Section 4.56 Modification Application: 219-231 Botany Road, Waterloo - D/2015/1358/C

File No.: D/2015/1358/C

Proposal Summary: Section 4.56 application D/2015/1358/C seeks to modify the previously approved concept building envelopes in order to match design elements within a concurrent detailed design DA (D/2020/1419).

Figure 17: Proposed concept building envelope plan

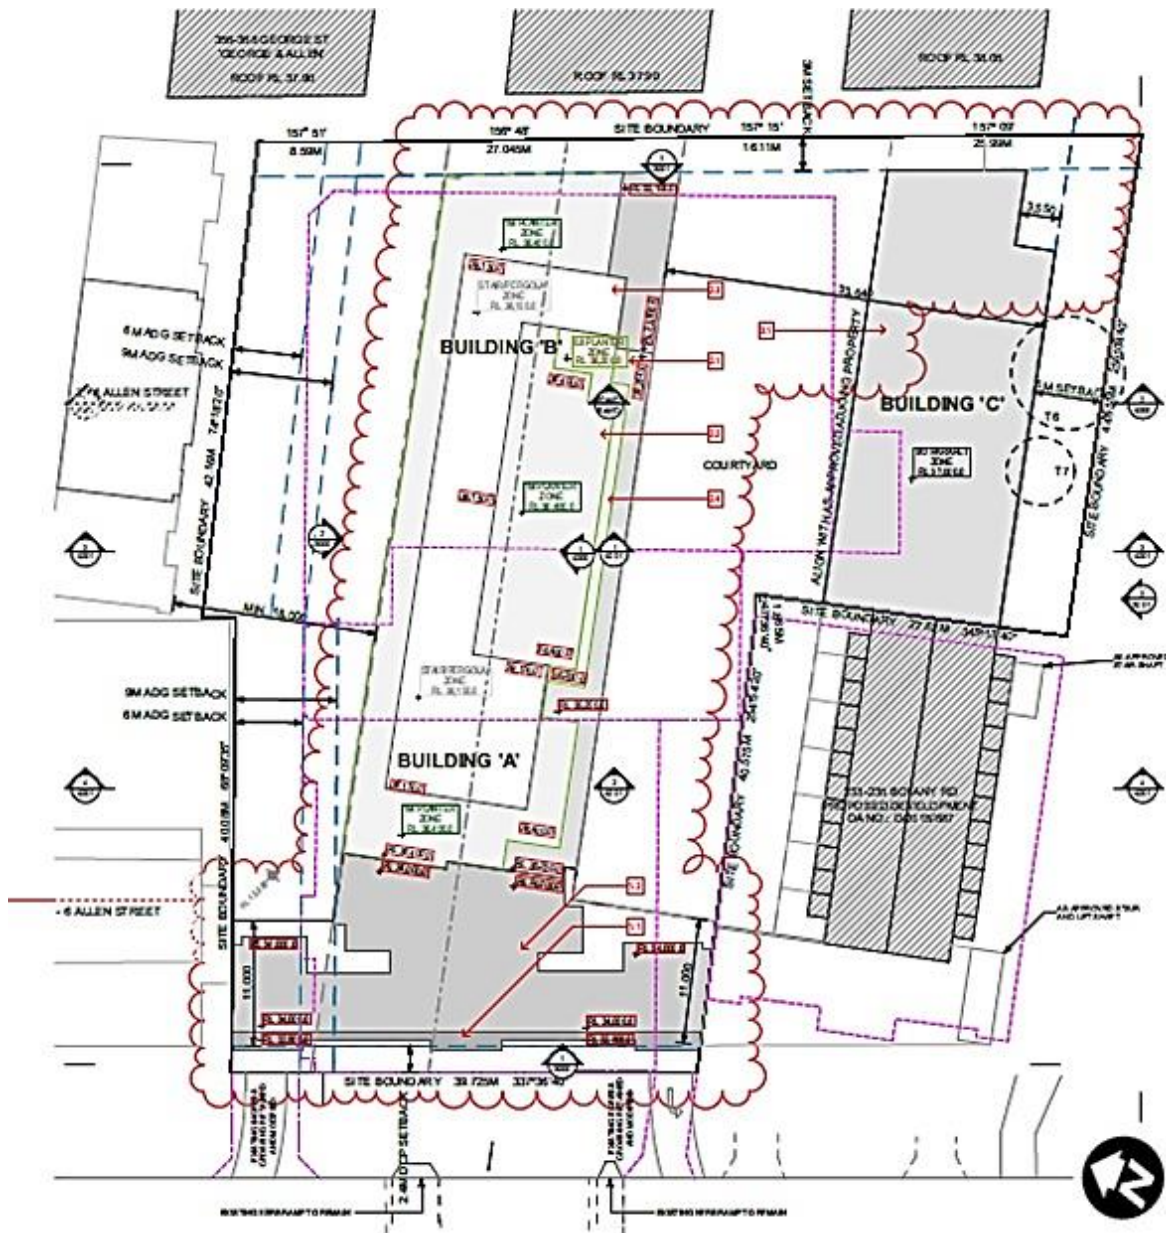
- 54. Plans and elevations of the proposed modified envelopes are provided below. The annotated numbers in red boxes shown in Figure 17 below are referred to in a schedule of proposed modifications to the concept envelope drawings. Selected drawings are available at Attachment B to this report.

Mod. no.	Proposed modification	Assessment
General		
Unnumbered	Replace plans for each floor from Basement to Roof levels with a single building envelope plan (drawing no. 2004, A).	<p>The replacement of concept plans for each level from basement to roof level with a single building envelope plan has been in an effort to simplify the concept envelope drawings and to minimise inconsistencies and errors across the drawing package.</p> <p>The simplification of the concept envelope plan is in accordance with Council's Planning Officer's recommendations and is supported.</p>
Unnumbered	Delete indicative locations of lift and stair overruns.	<p>Consent condition (6) Stage 2 To Be Contained Within Approved Envelope - this specifies that the detailed Stage 2 design scheme must be contained within the approved building envelope.</p> <p>Consent condition (7) Building Height currently states: 'With the exception of lift overruns, the maximum height of the buildings must not exceed the following...' the condition then goes on to specify the maximum heights of the approved concept envelopes.</p> <p>Like the proposed modification above, the deletion of indicative lift and stair overruns is to simplify and declutter the concept envelope drawings.</p> <p>The proposed modification is supported and it is recommended that conditions (6) Stage 2 To Be Contained Within Approved Envelope and (7) Building Height are amended to take a consistent approach to what structures are to be contained within the envelope and to refer to the modified building envelope heights as shown on the proposed envelope drawings.</p>

Mod. no.	Proposed modification	Assessment
2.1	<p>Southern portion of Building A and B envelope height previously ranged in height from RL 35.40 to RL 36.00 and is proposed to be adjusted to a consistent height of RL 35.25.</p> <p>Note: proposed modification 2.1 as described in the schedule titled Summary of Proposed Amendment, is incorrect and does not correlate with the RLs annotated on the plan.</p>	<p>The subject portion of the envelope, which comprises a narrow strip along the southern edge of the Building A and B envelopes, was previously approved to a height of up to 21.63m.</p> <p>The subject portion of envelope has a height of up to 21.4m and complies.</p> <p>The proposed adjustment to the height of the subject portion of the envelope is supported.</p> <p>Refer to the Issues section in this report for a detailed discussion about building height, view loss and overshadowing.</p>

Mod. no.	Proposed modification	Assessment
2.3	Portion of Building A and B envelope height previously ranged in height from RL 35.40 to RL 36.00 and is proposed to be adjusted to a consistent height of RL 38.15.	<p>The subject portion of the Building A and B envelope was previously approved to a height of up to 21.63m.</p> <p>The proposed increase in height to the subject portion of the envelope results in a height of up to 24.75m and which results in a 12.5% (2.75m) non-compliance with the LEP's 22m height control.</p> <p>The proposed increase in height to the subject portion of the envelope is to accommodate rooftop structures including pergolas, shade structures and facilities within the rooftop communal open space of the detailed design scheme and is supported.</p> <p>As discussed in the Issues section of this report, the proposed modifications to the envelope do not result in any increased overshadowing to neighbouring properties beyond that which would arise from the previously approved envelope.</p> <p>Refer to the Issues section in this report for a detailed discussion about building height, view loss and overshadowing.</p>

2.4	Portion of envelope set back from southern edge of Building B floor plate.	<p>It is this setting back of the envelope, along with the various heights incorporated to different portions of the envelope that allows for a larger envelope without increased overshadowing to neighbouring properties.</p> <p>For this reason the proposed modification is supported.</p> <p>Refer to the Issues section in this report for a detailed discussion about building height, view loss and overshadowing.</p>

Figure 26: Variations to 22m LEP height control arising from proposed modifications

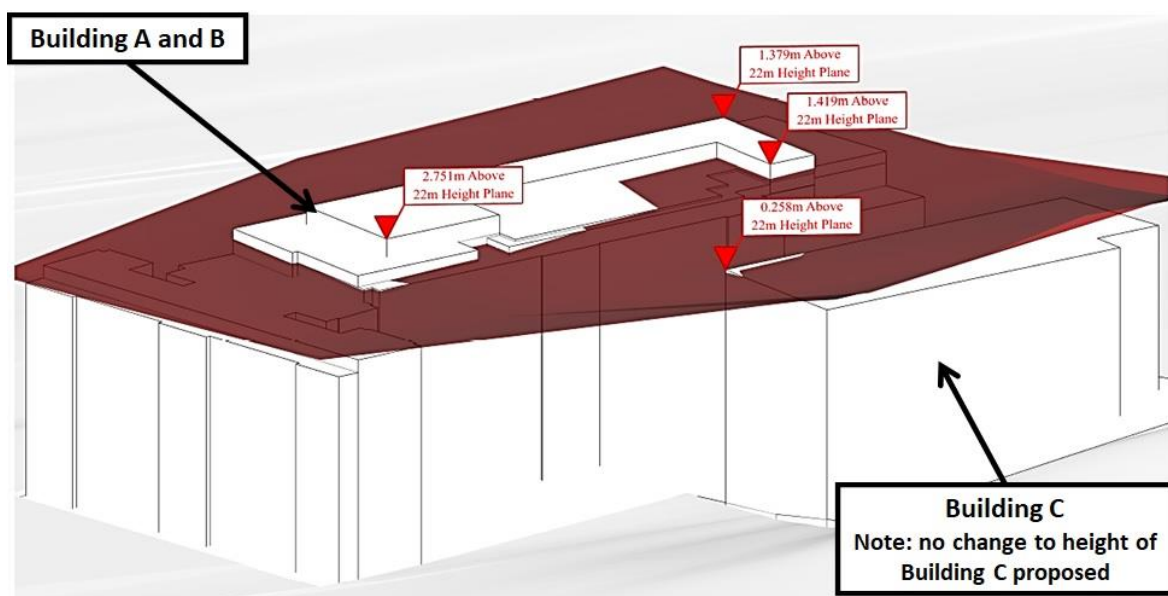
68. As shown in Figure 26 below and described in the assessment table above, the proposed modifications to the concept envelope for Buildings A and B exceed the 22m LEP height control by up to 2.751m. This is a 12.5 per cent variation of the control. Please note that the diagram in Figure 26 shows that Building C does protrude above the 22m height plane. This variation was approved under the original consent. There is no modification to Building C envelope proposed under the subject application.
69. Only the modifications to Building A/B envelopes lead to new breaches of the height control and which are assessed below.

assessment - as shown in Figure 26 above, the proposed modifications are to increase the height of various portions of the Building A and B envelope. The parts of the envelope that are proposed to be raised are setback from the street frontage to minimise impacts to the Botany Road streetscape. As discussed in the Overshadowing section of this report below, the subject portions of the envelope are also setback from the southern edge of the Building A and B envelope footprint to minimise impacts in accordance with ADG objective 3B-2: Overshadowing of neighbouring properties is minimised during mid-winter;

assessment - as shown in Figure 26 above, the parts of the envelope that are proposed to be raised are restricted to a central location within the site. The Building A envelope that fronts Botany Road complies with the 22m LEP height control and has no unacceptable adverse impacts upon the public domain;

assessment - as shown in Figure 26 above, the parts of the envelope that are proposed to be raised are setback from the street frontage and will not undermine any contribution that the future built form will make to the physical definition of the street network and public domain.

- 73. This consistency between the detailed design (stage 2) DA and the concept consent is a requirement of section 4.24(3) of the EP&A Act.
- 74. As illustrated in Figure 26 above, these portions of the envelope are set back from the southern edge of the Building A and B envelope footprint. These setbacks in massing have been incorporated into the proposed concept envelope design in consultation with Council Officers and are to minimise overshadowing of the adjacent residential apartments in the Belle and Lily building at 233-235 Botany Road.

Figure 30: Comparison of view from the sun (vfts) diagrams at 9am at midwinter, the approved envelopes (left) and the proposed modified envelopes (right). Envelopes in the subject site shown in orange and Belle and Lily shown in yellow.

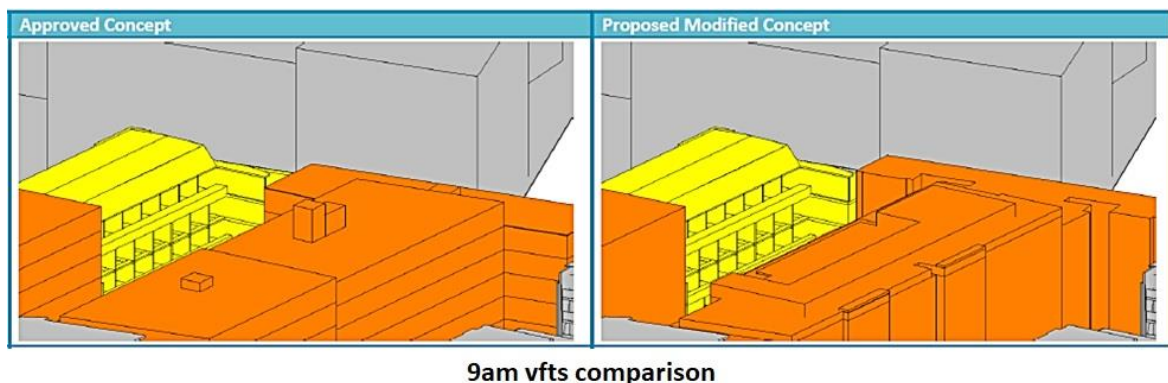
83. As illustrated in the Figures below, the modifications to the concept envelopes proposed under the subject application (D/2015/1358/C) do not exacerbate overshadowing to the Belle and Lily apartments beyond that which would arise from the concept envelopes as originally approved.

84. That is, 55 per cent (16 of 29) of the Belle and Lily apartments receive at least 2 hours of solar access to living rooms and private open spaces between 9am and 3pm at mid-winter and 7 per cent (2 of 29) of apartments receive no direct sunlight.

Figure 37: Excerpt of proposed envelope plan illustrating portion of envelope at south-east corner of Building B to be reduced in height from RL 36.00 down to RL 33.10.

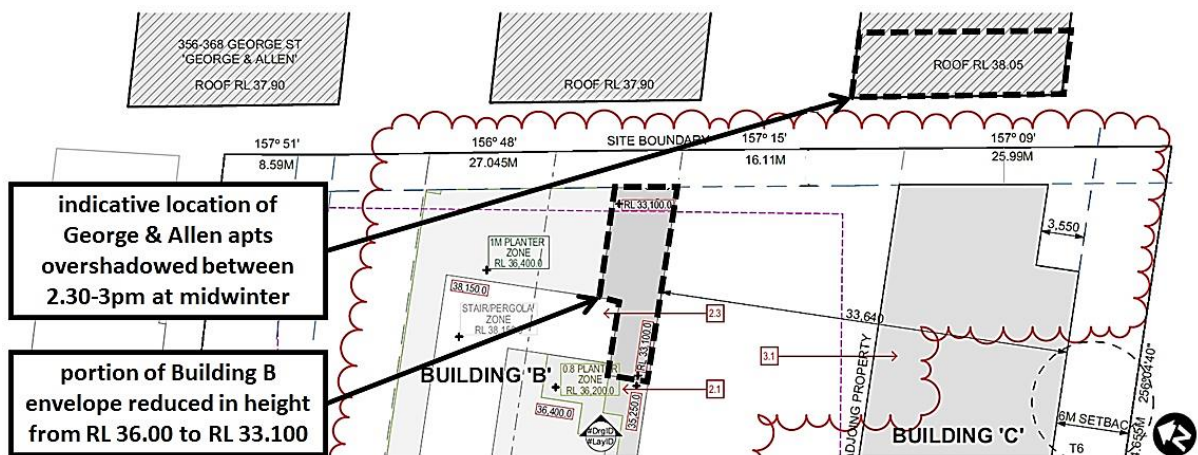
85. As shown in Figure 37 below, the modifications proposed under the subject application include a reduction in height to a portion of the Building B envelope at its south-eastern corner, from RL 36.00 down to RL 33.10.
86. The south-eastern corner of the Building B concept envelope approved under the original consent (D/2015/1358) overshadows the ground and first floor apartments in the north-western corner of the southernmost building within the George and Allen site between 2.30 and 3.00pm at midwinter.
87. The modifications to the concept envelopes proposed under the subject application (D/2015/1358/C) do not exacerbate overshadowing to the George and Allen apartments beyond that which would arise from the concept envelopes as originally approved.

Figure 40: Approximation of view impacts arising from the originally approved envelopes.

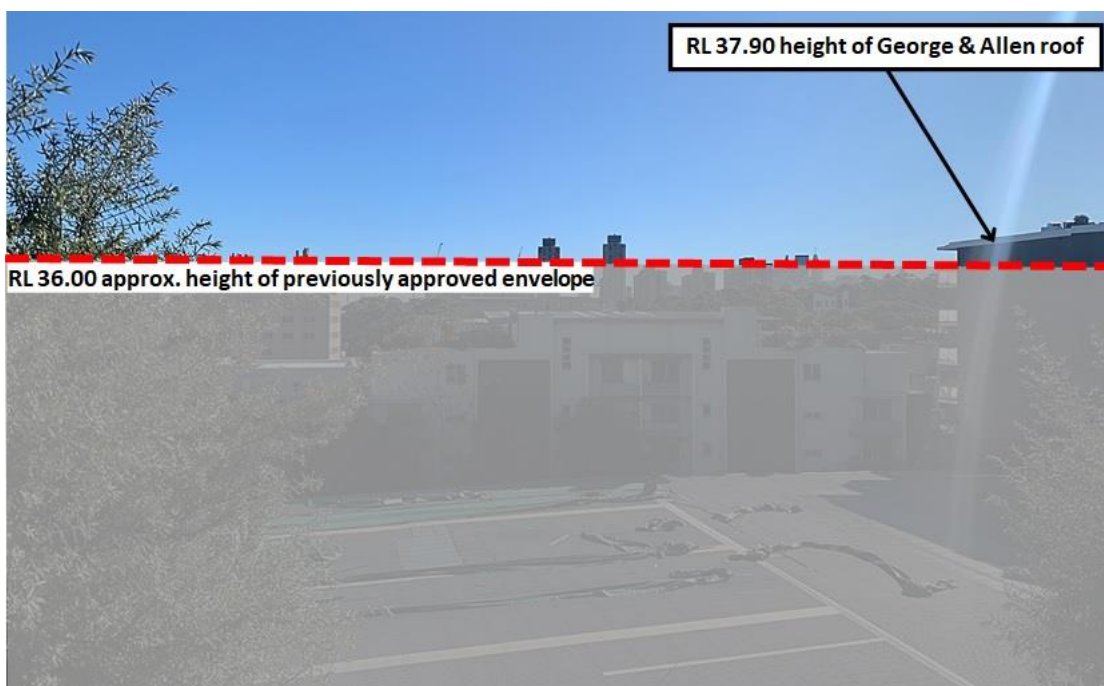
- (b) as shown in Figure 40 below, the concept envelopes as originally approved would have blocked most of the views of the City skyline. The remaining views of the City skyline that are likely to be blocked by the modifications proposed under the subject application could only be considered very partial views. Consistent with a Tenacity assessment, these remaining views are of a low value.

94. Extent of the impact -
- (a) As shown in Figure 40 below, the concept envelopes as originally approved would have blocked most of the views of the City skyline and other buildings in Redfern and Waterloo, with the exception of the tallest towers of the Waterloo Estate.

Figure 41: Approximation of view impacts arising from the proposed modified envelopes.

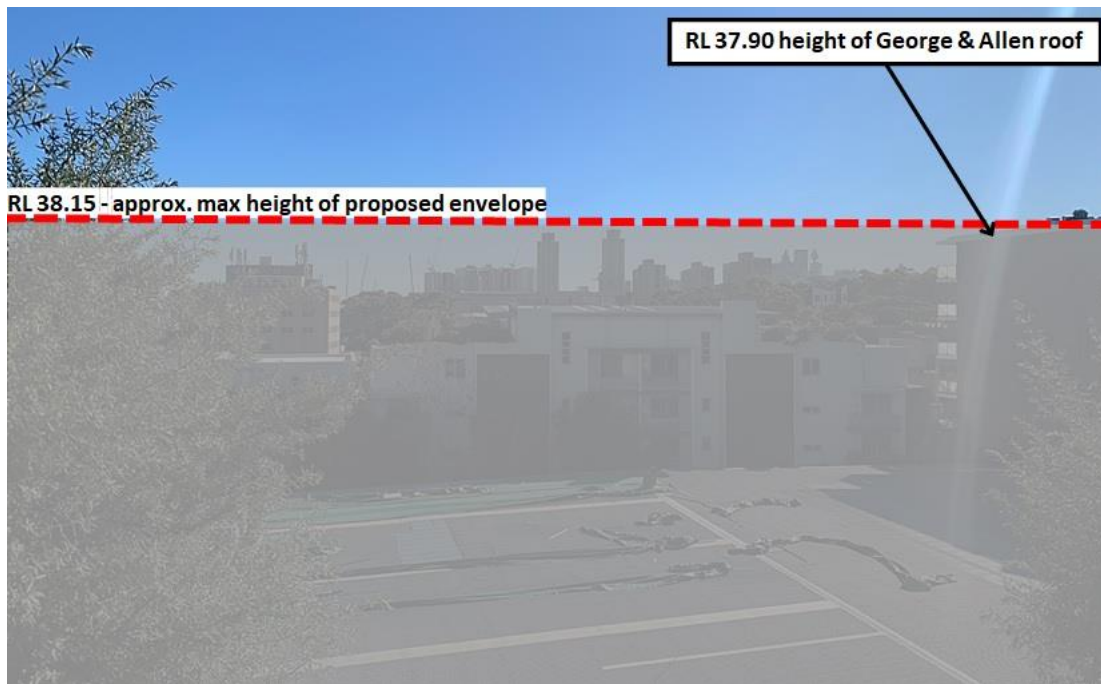
- (b) As shown in Figure 41 below, the proposed modifications to increase the height of the Building A and B envelope will block out the last glimpses of those tallest towers of the Waterloo Estate. According to Tenacity, the extent of the impact in this case is minor.
